DESIGN REVIEW COMMITTEE

January 21, 2026 6:00 PM

AGENDA

BUILDING ELEVATIONS

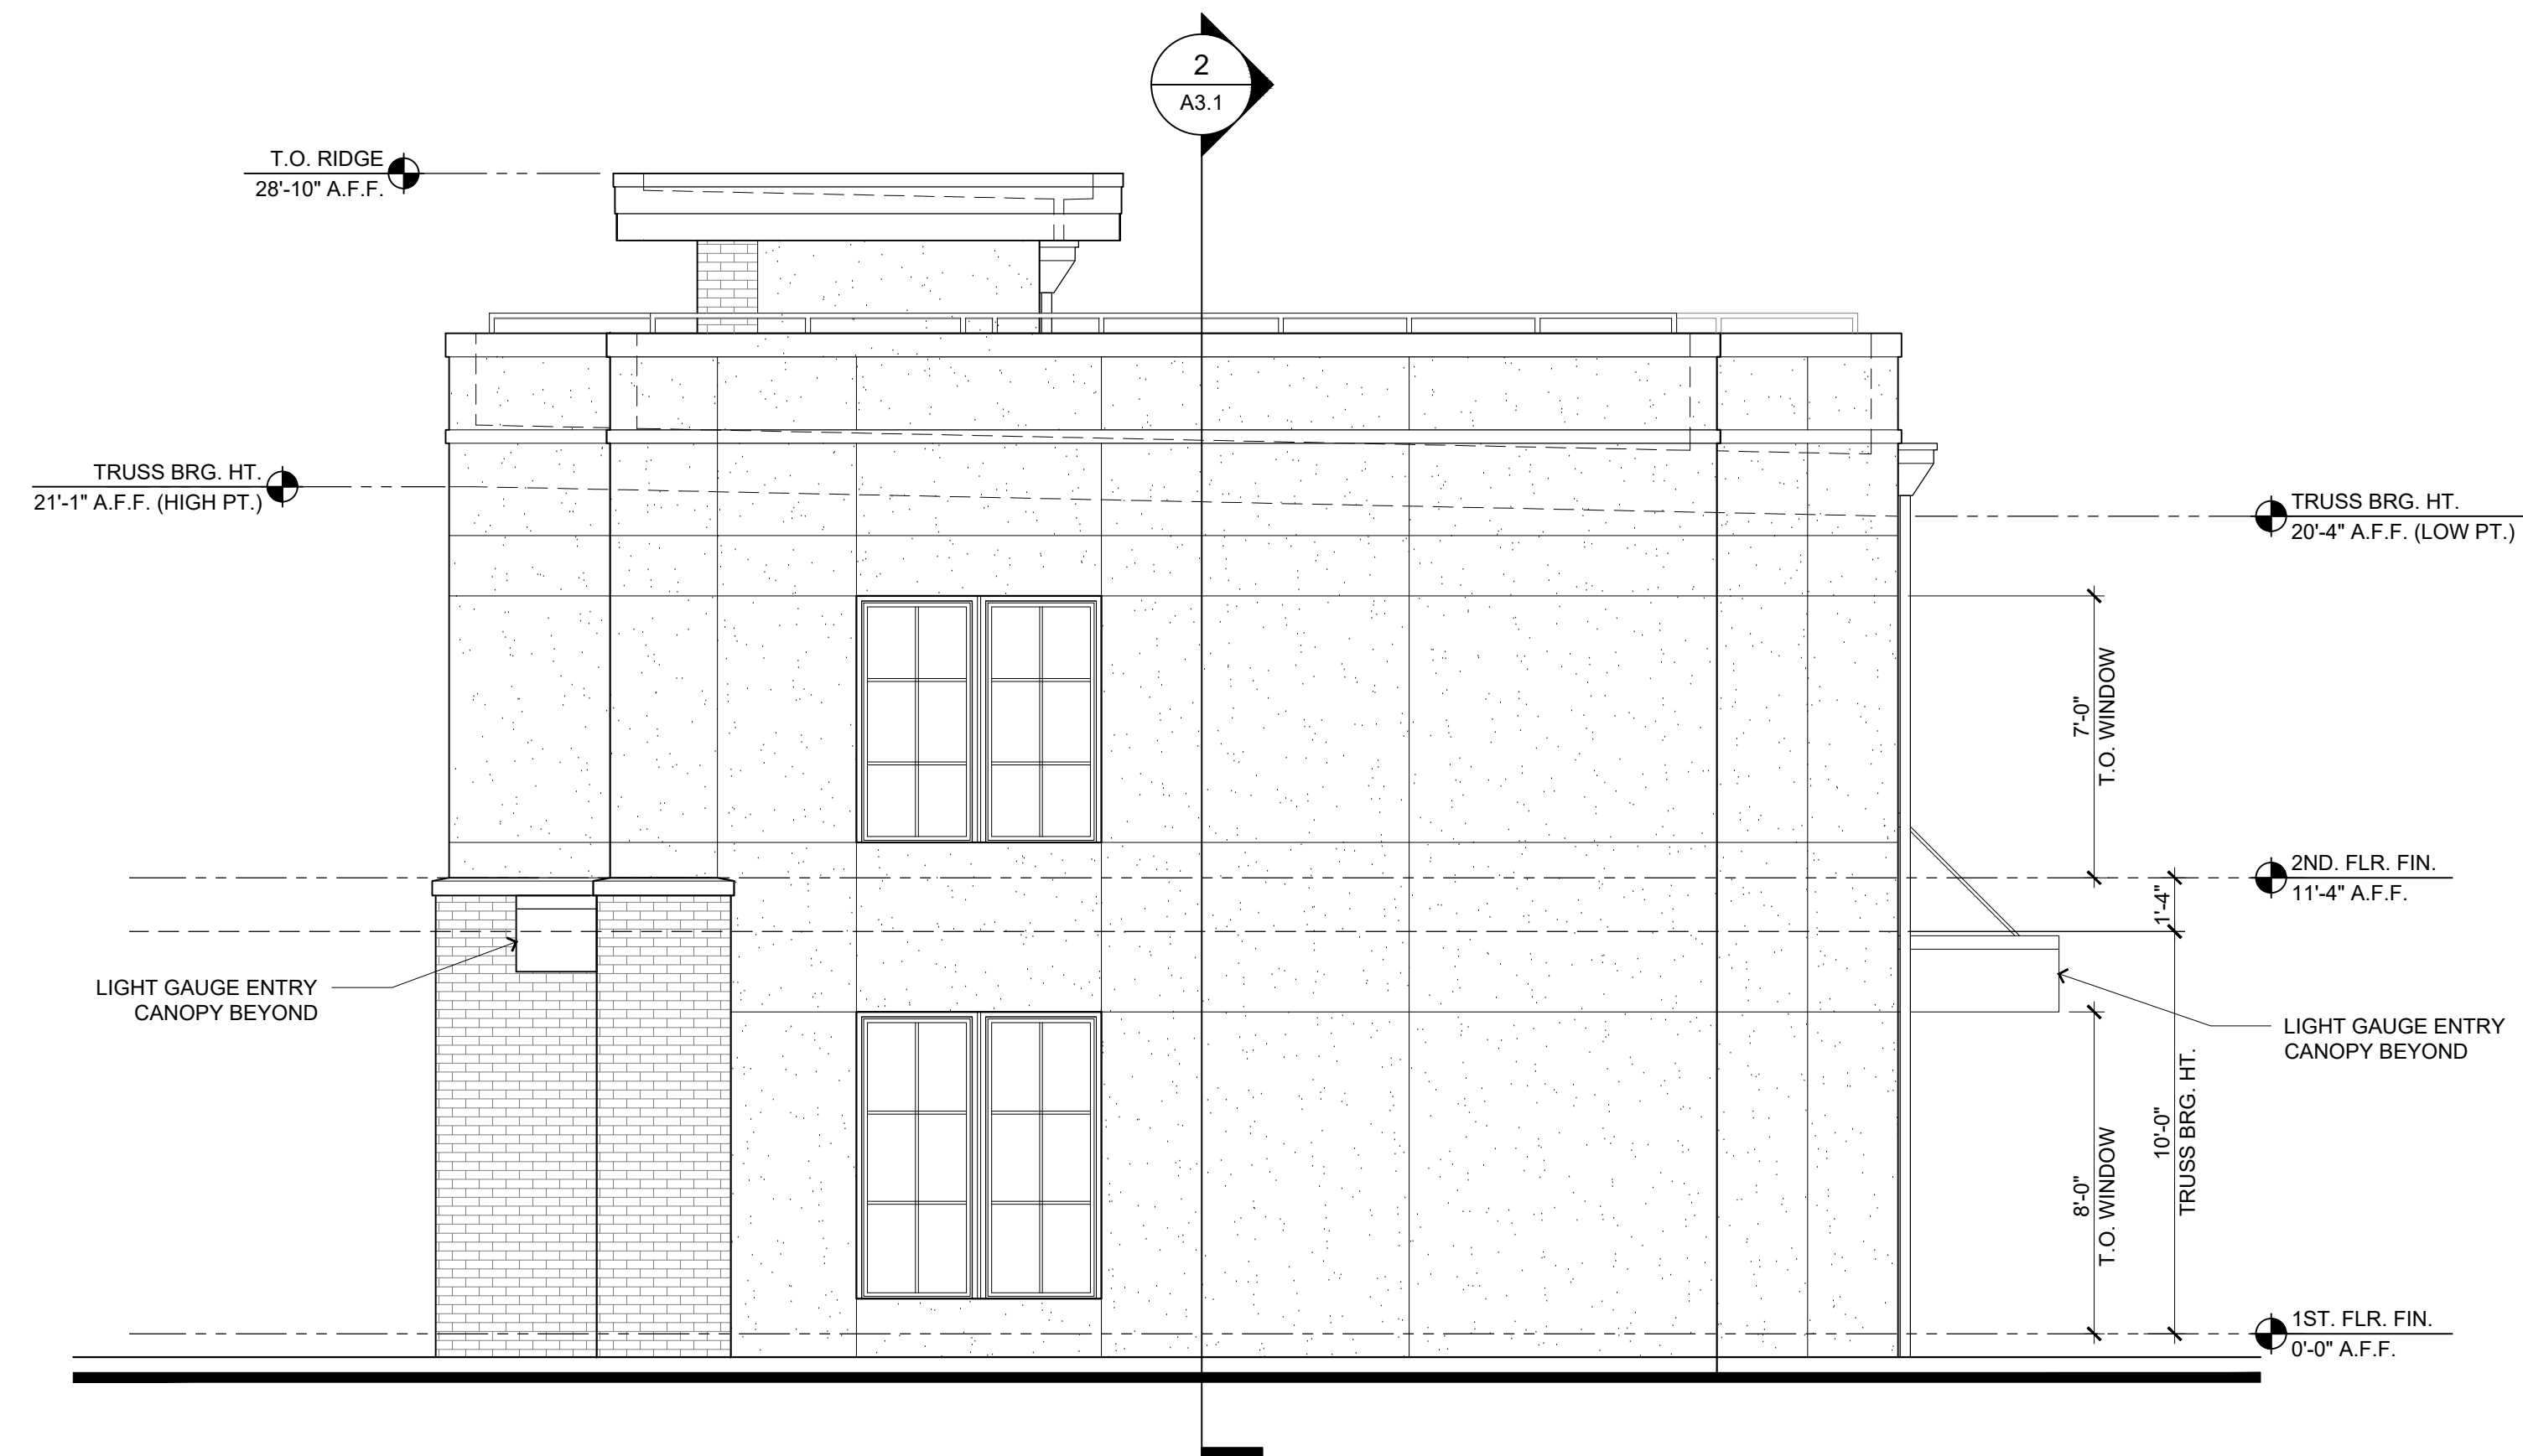
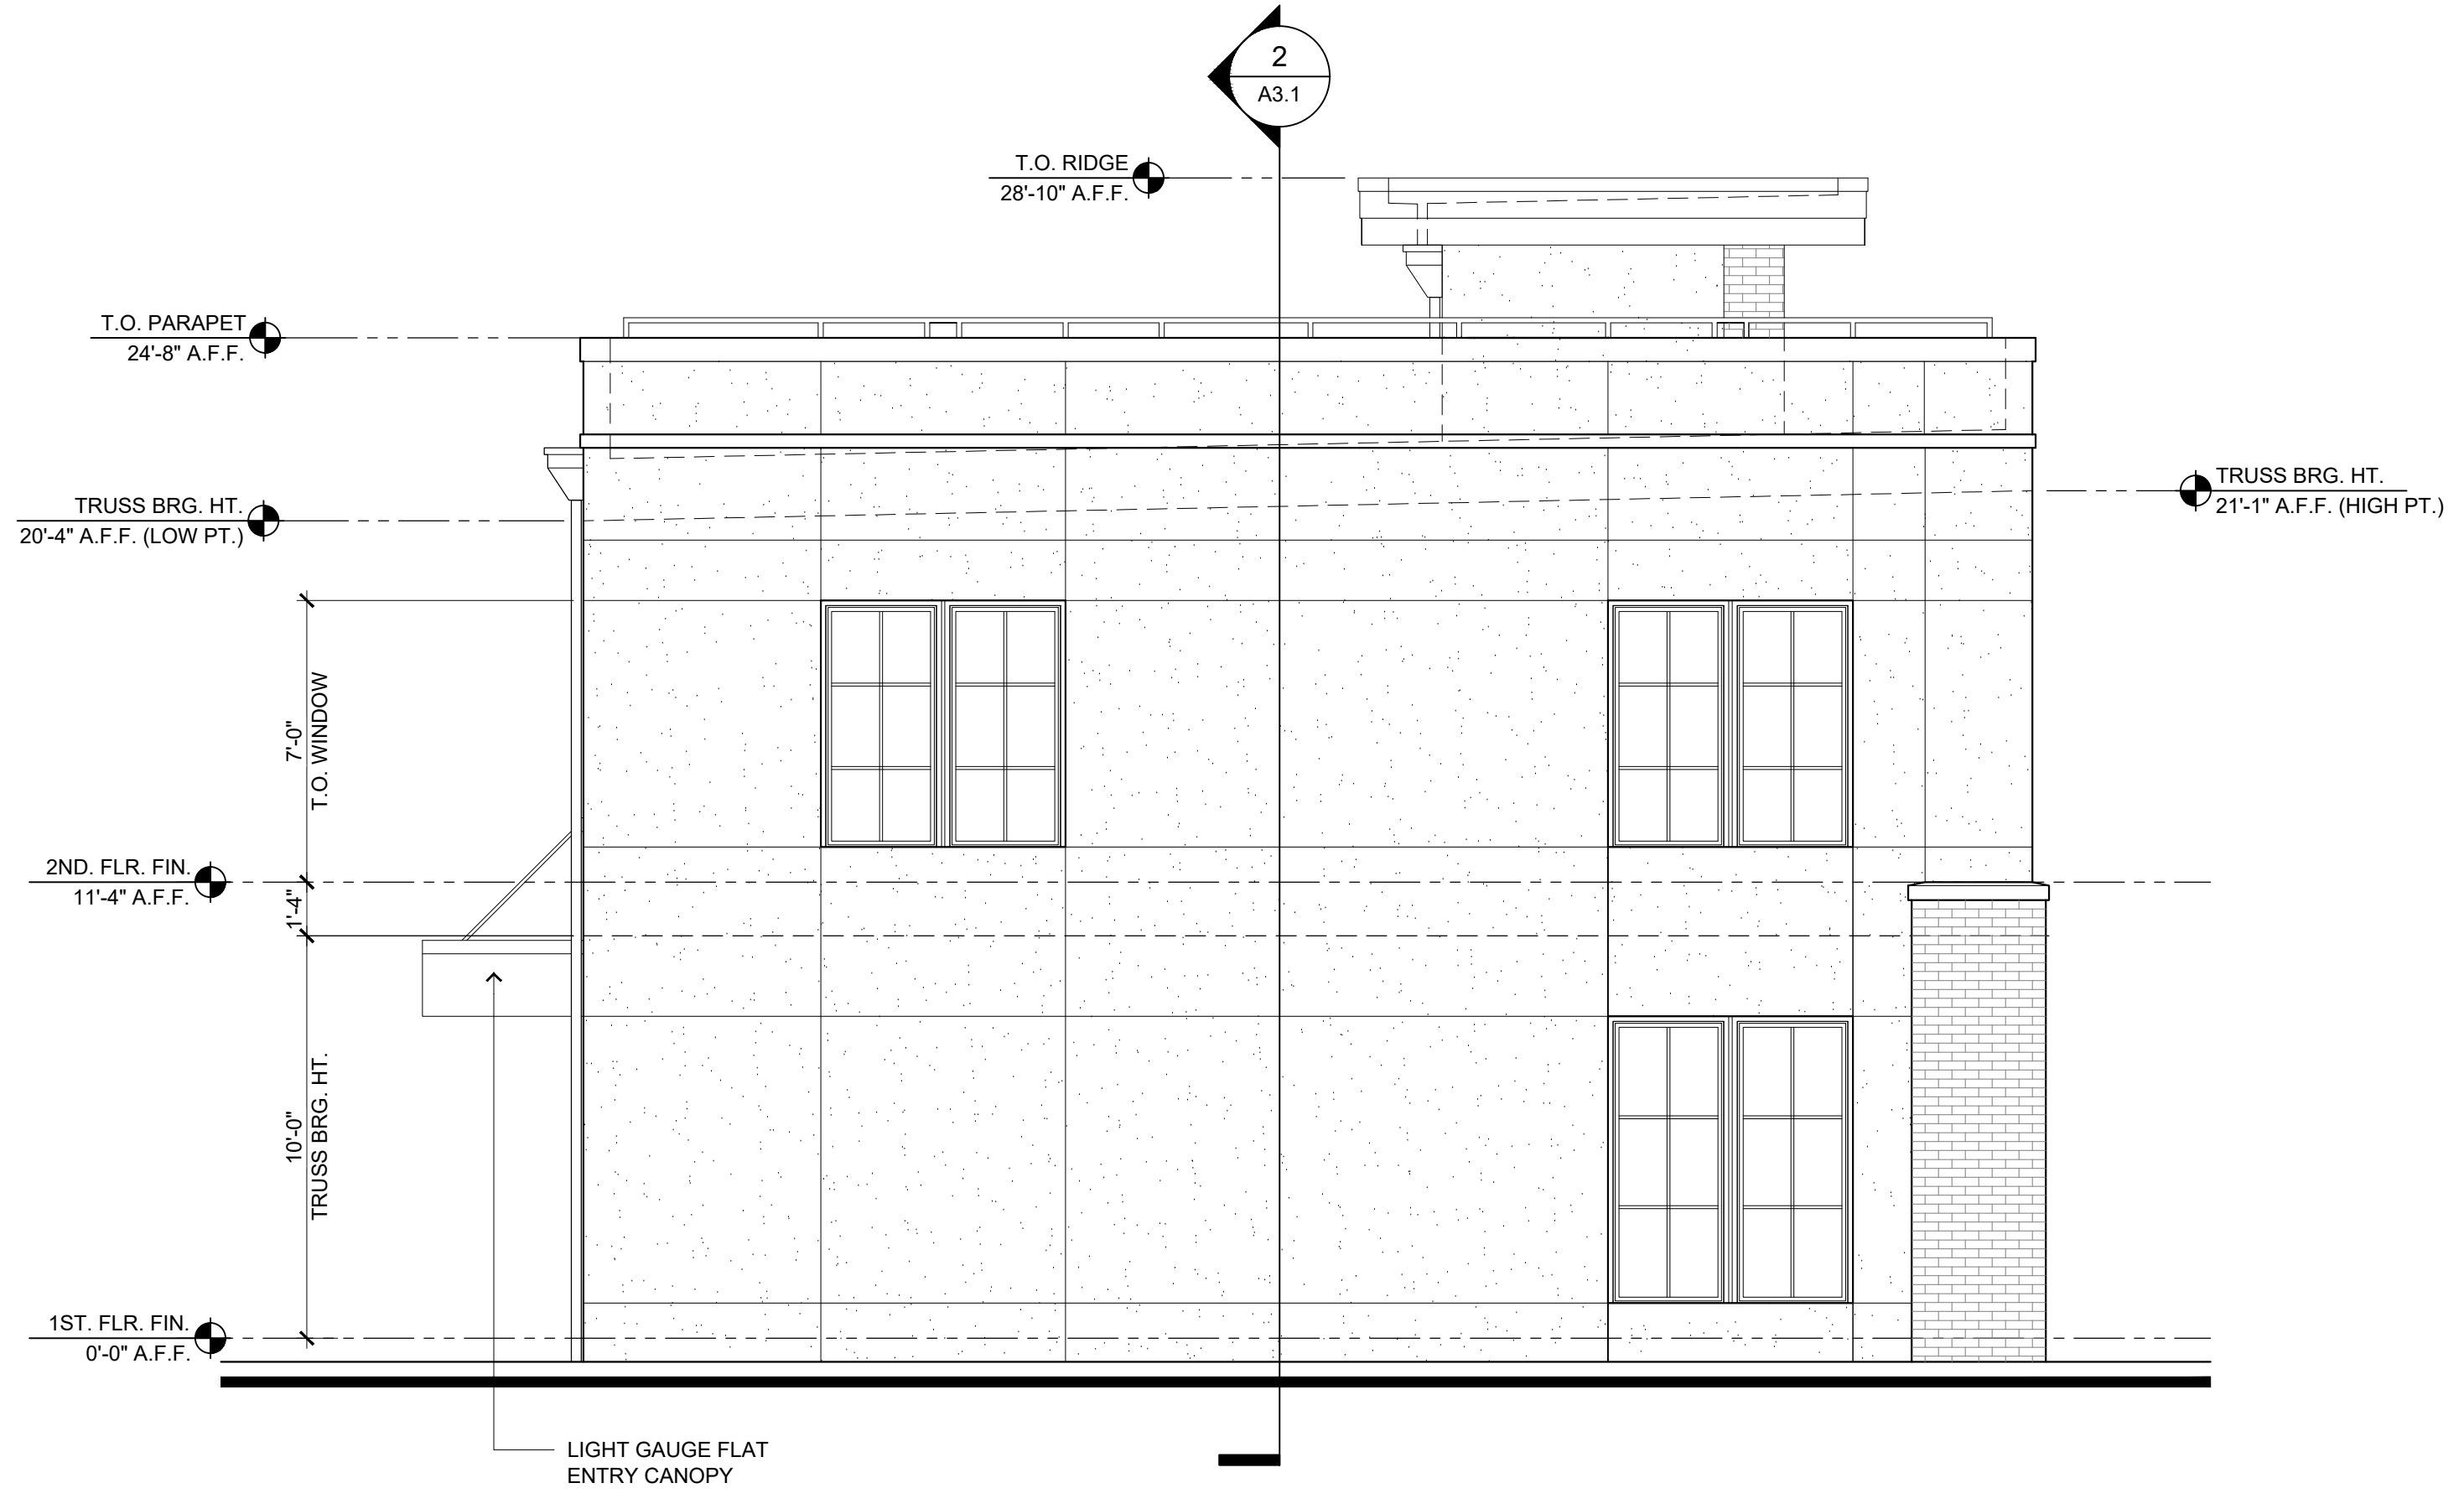
The requested change is to modify the windows from double-hung divided light windows to large pane windows on the lower and upper floors.

Proposed Change:

Front Elevation:

1. The revised elevation shows a double door with no side-lites and a double-glazed transom with no dividers above the main door.
2. The three 1st floor windows are single windows with no center mullion and no divided lites.
3. The three 2nd floor windows are single windows with no center mullion and no divided lites.
4. The large window above the front entry is separated horizontally with three panels of glass.

Right Side Elevation:

1. The single 1st floor window is a single window with no center mullion and no divided lites.
2. The single 2nd floor window is a single window with no center mullion and no divided lites.

Left Side Elevation:

1. The single 1st floor window is a single window with no center mullion and no divided lites.
2. The two 2nd floor windows are single windows with no center mullion and no divided lites.

Rear Elevation:

1. The single 2nd floor window is a single windows with no center mullion and no divided lites.

No dimensions for the new windows were provided. The glass transoms on the lower floors are not present. The heights of the windows are not provided to determine if the 10' to 12' dimension has been met. It is not clear if the front door is still 70% glass. The upperstory windows do not have the vertical shape as required above. The lower story windows are also not as vertically pronounced as the approved windows. The applicant should provide additional information per above. The Design Review Committee may assess whether the revised windows meet the intent of the storefront treatment as prescribed in the Standards.
